NRC-013

Combined License Application Review William States Lee III Units 1 and 2 Safety Panel October 5, 2016

Lee Site Foundation Response Spectra (WLS DEP 2.0-1)

Lee Site Foundation Response Spectra

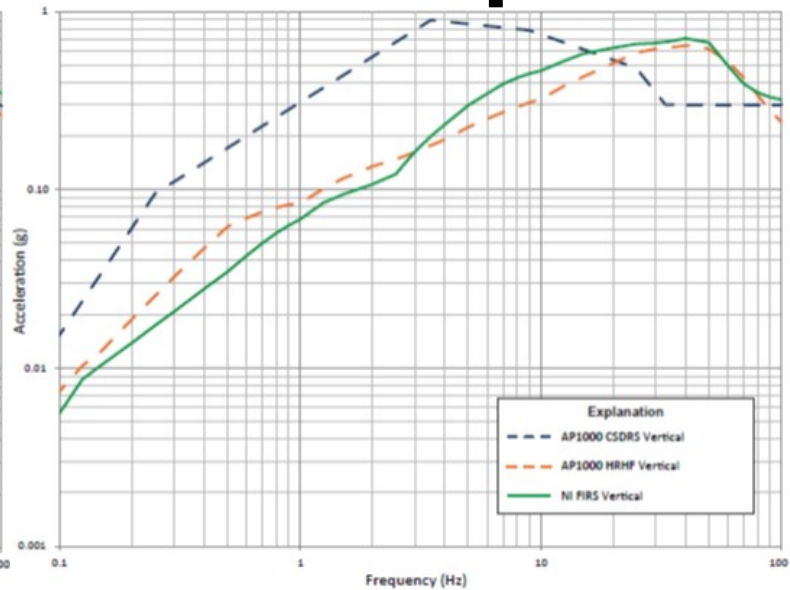
- **Exceeded the AP1000 CSDRS and HRHF spectra in the high frequency range.**
- **Required site-specific seismic evaluations of SSCs per the AP1000 DCD.**

- **Site-specific evaluation was performed to demonstrate the high frequency exceedance is non-damaging.**
- **ISRS at DCD defined locations showed small exceedances.**

- **Site-specific forces on NI SC-I structures are bounded by AP1000 forces.**
- **No physical interaction occurs between NI SC-I and adjacent SC-II structures.**

- **Site-specific forces and stresses on primary components and piping systems are bounded by AP1000 forces and stresses, respectively.**

- **Site-specific RRS for representative high frequency sensitive equipment are bounded by the AP1000 TRS.**
- **All future TRS will envelope the site-specific RRS.**
